Alberhill System Project

ENERGY DIVISION STAFF REPORT

September 15, 2023

The purpose of this Energy Division Staff Report is to detail the review and analyses the California Public Utilities Commission Energy Division has conducted to date related to Southern California Edison's supplemental information filed in response to CPUC Decision 18-08-026.

Figure 1: Proposed Alberhill Project Tie-Lines (Proposed Alberhill Project Energy Division Briefing Deck 2018)

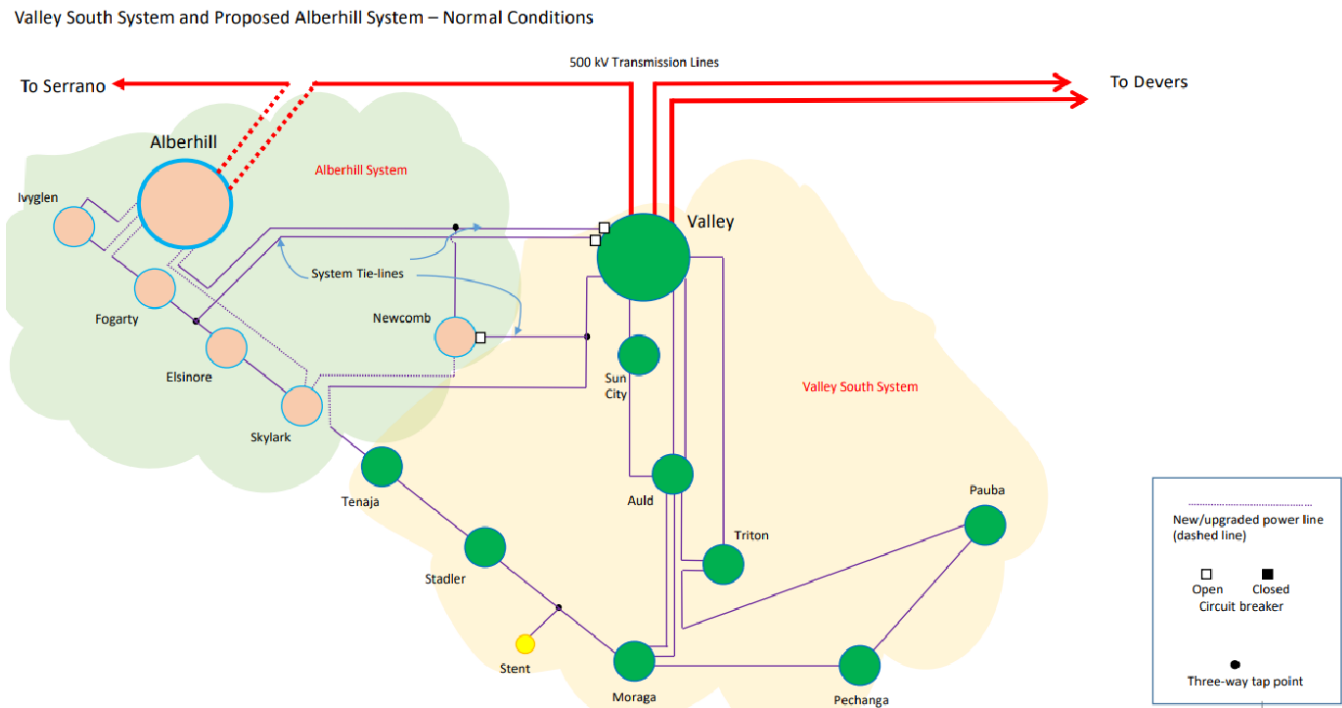
SCE did not specify in their original Planning Study the way the transfer of load from Valley South to the proposed Alberhill Project would occur in the event of an Auld-Moraga #1 overload. Based on the review of SCE’s studies, Kevala considered the ability of the proposed Alberhill Project to reconfigure its system under outage conditions to be an SPS, at that time. To provide an equal basis for comparison between other projects that did not include, what at that time was believed to be, the benefit of an SPS, that transfer was excluded from Kevala’s study.

- In the Planning Study, SCE does not specify the way the transfer of load from Valley South to proposed Alberhill Project would occur to remedy an Auld-Moraga #1 overload in the event of a contingency. SCE clarified in the Draft Staff Report comments that this transfer of load would be a manual action, as opposed to an automated scheme (SCE 2022c). Because of this learning that this transfer of load would be a manual action, the following conclusions were determined in 2022:

of SCE’s Planning Study. SCE’s Planning Study concluded that tie-lines would not be effective in resolving double contingencies or a catastrophic loss of both transformers in the Valley South System. As previously discussed in Section 2.3, Kevala assumed that tie-line transfers occurring were an SPS and so excluded those transfers from the power flow study. This exclusion and evaluation for different forecast years fundamentally altered the results of the power flow study, creating the difference between the Kevala and SCE conclusions.

Figure 2: Differences in Independent Capital Analysis BCA and SCE's PVRR Analysis BCA

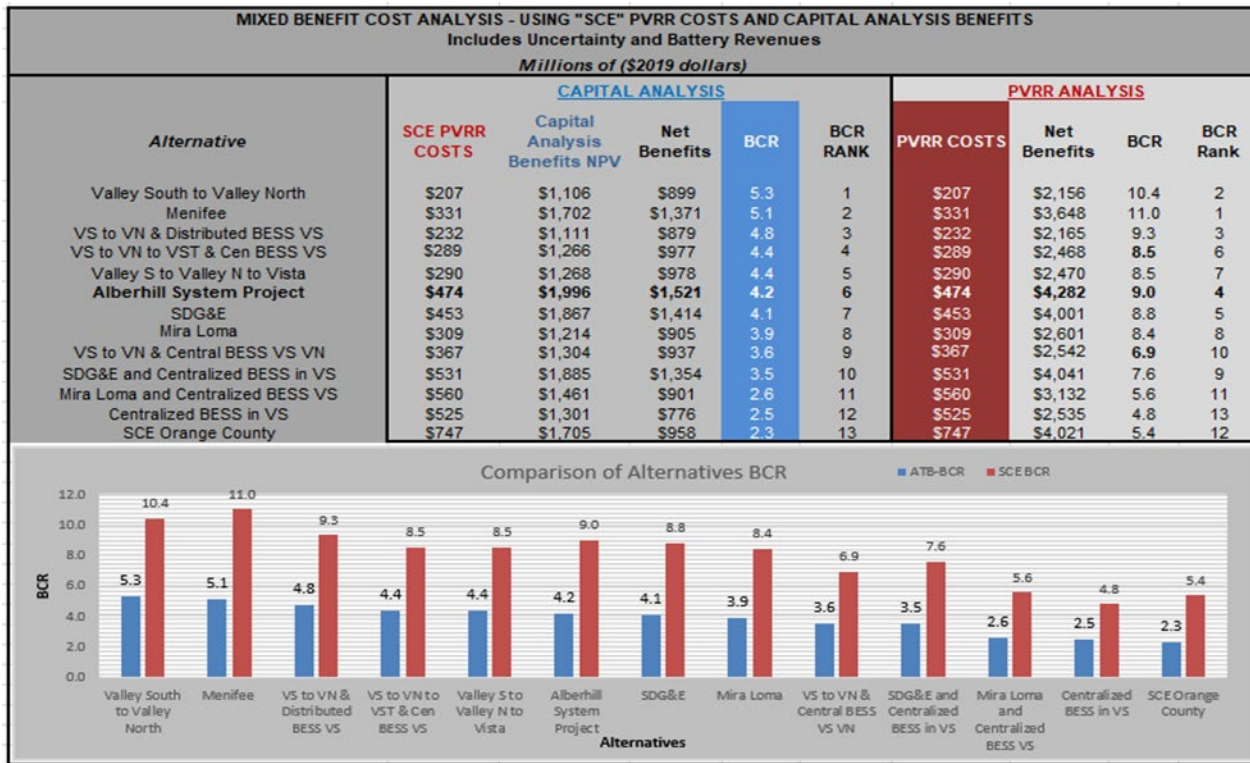
Based on the retiming of benefits beginning to accrue on the appropriate Project in-service date, the most attractive alternatives (in terms of the benefit-cost ratio) were Valley South to Valley North (ranked in first place), Menifee (second place), and Valley South to Valley North and Distributed BESS in Valley South (third place). The proposed Alberhill Project was ranked in sixth place, followed by SDG&E (seventh place) and Mira Loma (eighth place).

SCE documentation emphasizes that the proposed Alberhill Project supplies the best solution in meeting the energy needs of the future, based on its reliability performance. This is paramount to the proposed Alberhill Project’s attractiveness and ultimately displaced all other alternatives as the preferred alternative. Although the reliability of energy capacity needs may justify the proposed Alberhill Project as the best solution, it is also a very costly solution, at \$474 million. In comparison, Valley South to Valley North (first place in terms of WSP’s BCA ranking) costs are only \$207 million; however, it is unclear how this and other alternative systems would perform giving equal consideration to their cost effectiveness, reliability performance, and capacity over time.

Figure 4: Alberhill System Project special protection scheme

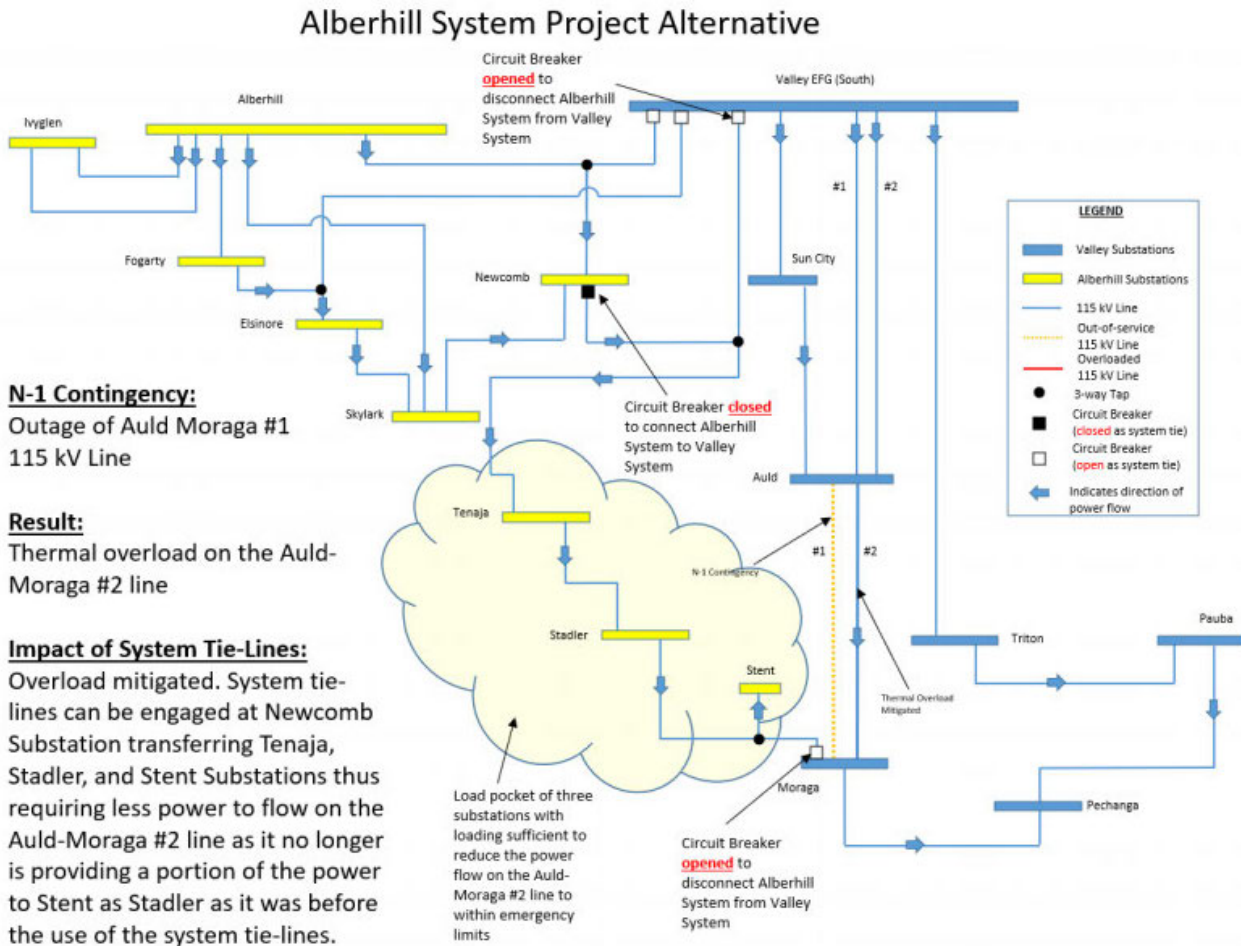
- Section 6.2 of the Draft Staff Report raised a question about whether an SPS is applied to the proposed Alberhill System Project. As described above in Section 2.4, SCE does not specify the manner in which the transfer of load from Valley South to proposed Alberhill Project would occur to remedy an Auld-Moraga #1 overload in the event of a contingency in their planning study. SCE clarified in the Draft Staff Report comments that this transfer of load would be a manual action, as opposed to an automated scheme (SCE 2022c). Based on the NERC definition of an SPS (NERC 2013), this means that this transfer is not an SPS.

The illustration in Figure 4 below, appears to show a special protection scheme (SPS) in use to alleviate the Auld-Moraga 115 kV #2 line overload. Without the deployment of this SPS, it would appear that the ASP does not relieve this overload. Kevala’s power flow analyses showed that when one Auld-Moraga 115 kv line is out of service, the remaining Auld-Moraga 115 kV line experiences an overload. This result was consistent for all alternatives and ASP. Therefore, it appears that without the use of a SPS, the tie-lines in the Valley South to Valley North alternative are as effective as those in the ASP.

Figure 2. BCA 1: BCA Capital Analysis Compared to SCE BCA PVRR Analysis (includes Uncertainty and Battery Revenues)

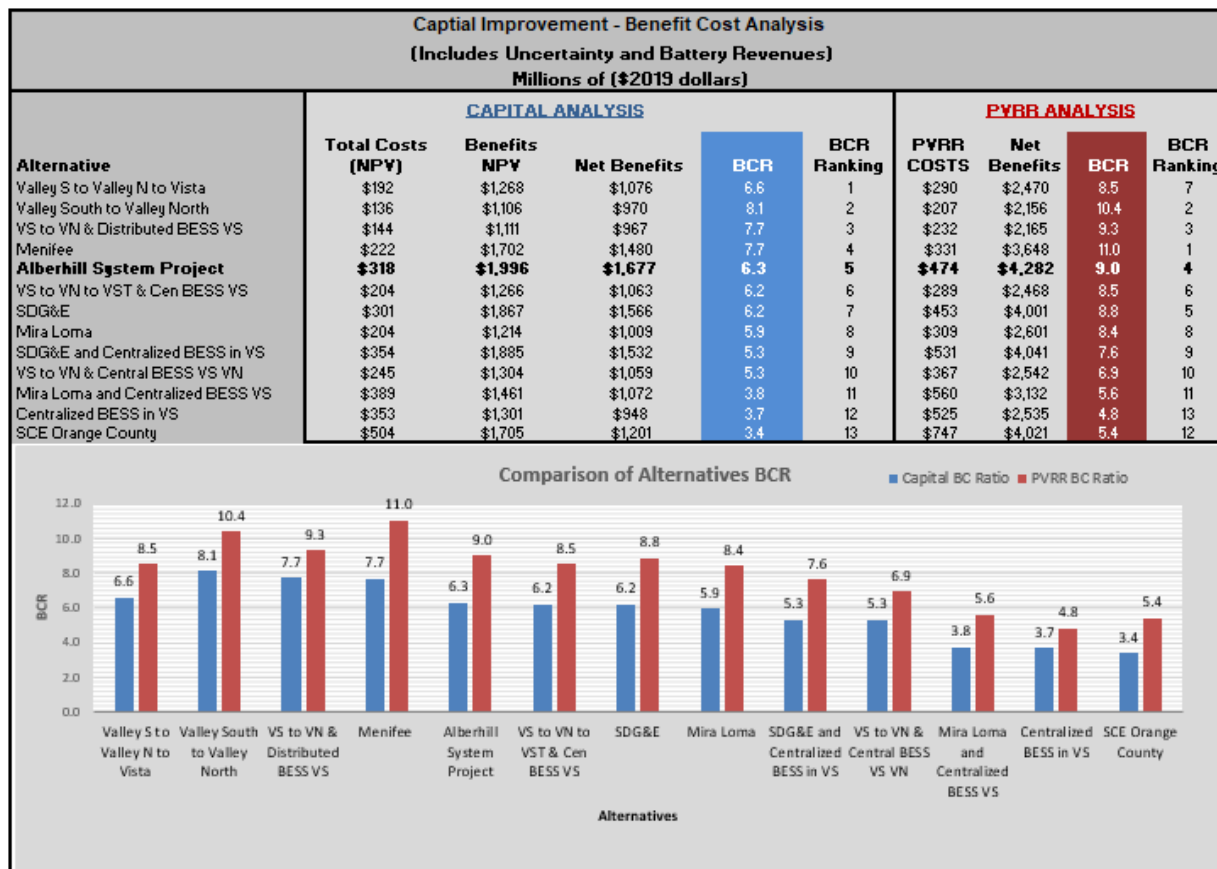
BCA1, a time series analysis, is a traditional capital improvement benefit cost analysis. It does not use SCE’s PVRR computations, rather it uses the estimated stream of undiscounted capital costs, O&M costs, and benefits (as provided in SCE’s spreadsheets), all timed correctly, over the project life span, including both uncertainty and battery revenues, then discounted these expenditures equitably using a 10 percent discount to a common point in time (the base year). This analysis resulted in the following BCR rankings. SCE BCRs and net benefits are consistently higher than the capital analysis (of BCA1) among all alternatives, which brings up the question *was the PVRR figure appropriately discounted?* In any event, conducting the capital analysis using the 10 percent discount rate reveals that the Alberhill System Project (Alberhill) is similarly ranked fifth with a BCR of 6.3; however, with the SCE analysis, Alberhill was ranked fourth with a BCR of 9.0. In terms of net benefits, BCA1 model shows a net benefits reduction from \$4.3 million to \$1.7 million, but Alberhill remains first in both evaluations.²

² The analyst did not change benefits, as calculated by SCE, except for adjusting them in time and how those benefits are discounted, (i.e., ensuring benefits begin after construction is completed).

Figure 3. BCA 2: BCA Capital Analysis Compared to SCE BCA PVRR Analysis (excludes Uncertainty and Battery Revenues)

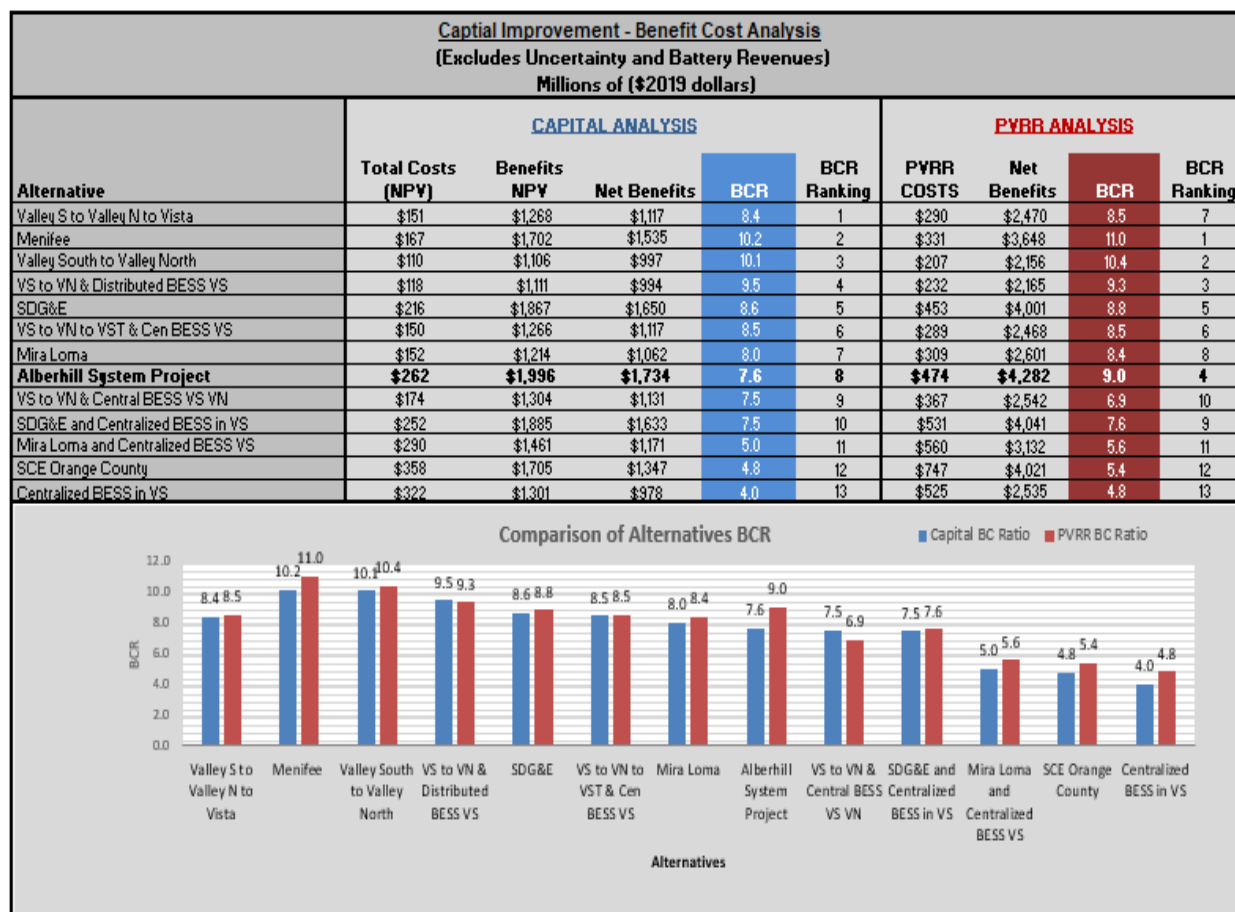
BCA2 is similar to BCA1 but excludes uncertainty and battery revenues from the costs streams, while all other time series factors remain the same. Although excluding uncertainty and battery revenues from the capital analysis has closed the BCR gap (between the capital and PVRR analyses), net benefits still are considerably divergent. This can be explained in part from the fact that the SCE benefits were not appropriately treated (discounted) in the year the projects become operational. The reason for the divergence in the costs is unknown. In any event, Alberhill moves to eighth in the BCR ranking compared to fourth with SCE evaluation. In terms of net benefits, as shown in Figure 3, several alternatives show similarly sized net benefits (in the range of \$1.7 million to \$1.9 million) when compared with Alberhill.

Figure 4. BCA 3: BCA Capital Analysis Compared to SCE BCA PVRR Analysis (includes Uncertainty and Battery Revenues)

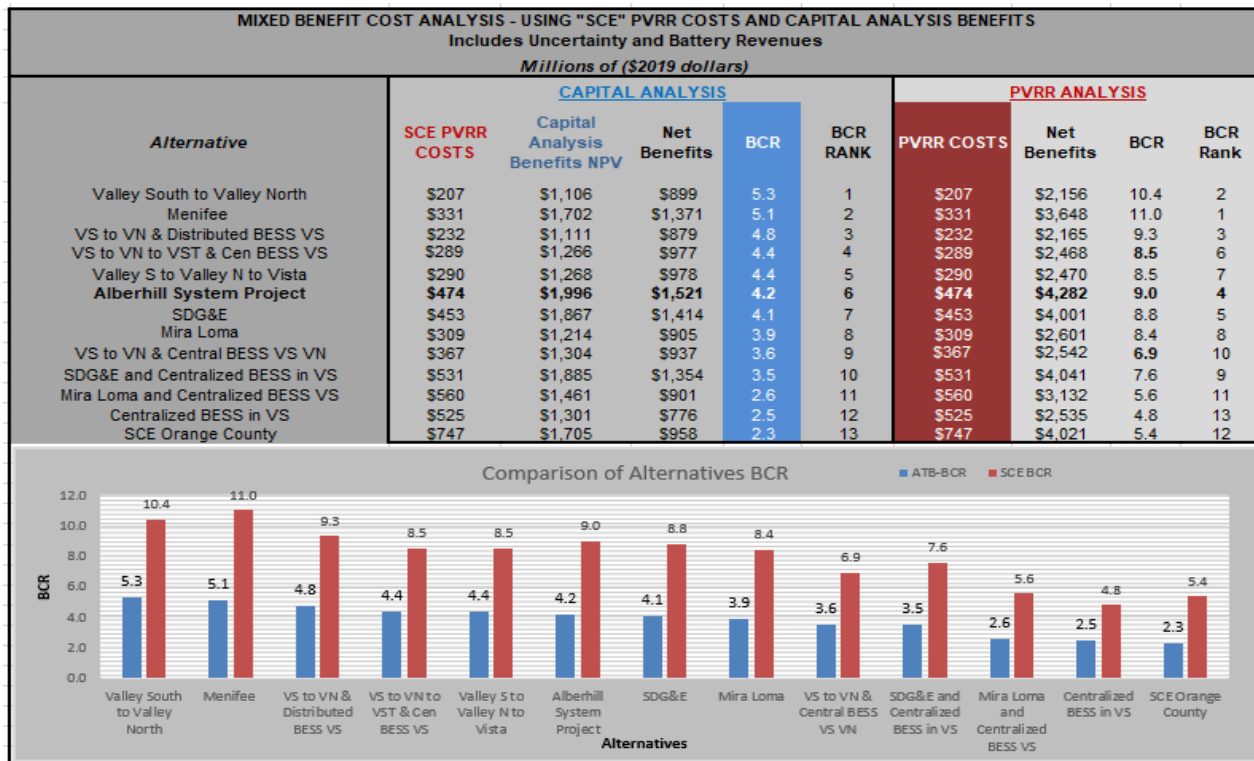
Similar to BCA1, BCA3 is a hybrid capital improvement benefit cost analysis. Unlike BCA1, BCA3 uses SCE’s PVRR computed costs and coupled with SCE’s benefits timed correctly (including battery revenues and uncertainty). Under BCA3, Alberhill places sixth in the BCR ranking, and in terms of net benefits, as shown in Figure 4, several alternatives show similarly sized net benefits (in the range of \$1.7 million to \$1.9 million) when compared to Alberhill.

In terms of the Alberhill System Project, BCA1 (using a 10% discount rate) has a total project cost of \$318 million (net present value) while BCA3 (using SCE’s PVRR computed costs) has a much larger total project cost of \$474 million (net present value). While BCA1 and BCA2 use different methods for computing total project costs, both BCA1 and BCA2 include uncertainty and battery revenues, times the accrual of benefits based on their actual occurrence (in-service, operational date), and all other factors are held constant.
